Your evaluation of the 4/23 incident would have been more complete and accurate if mention were made of these items:

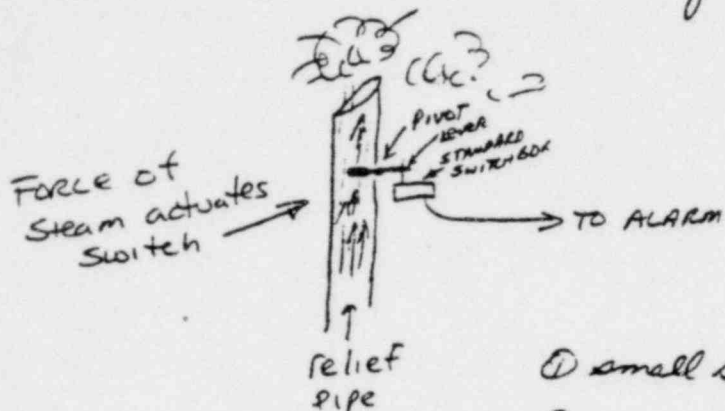
⑥ You might want to consider a mechanical switch to actuate an alarm which indicates the steam safeties are lifting. It would be actuated by the steam flow and seems more reliable than a sound actuated system.

- ① small surface area
- ② near side of pipe
- ③ near top of pipe so that leakage pasted lever is inconsequential.
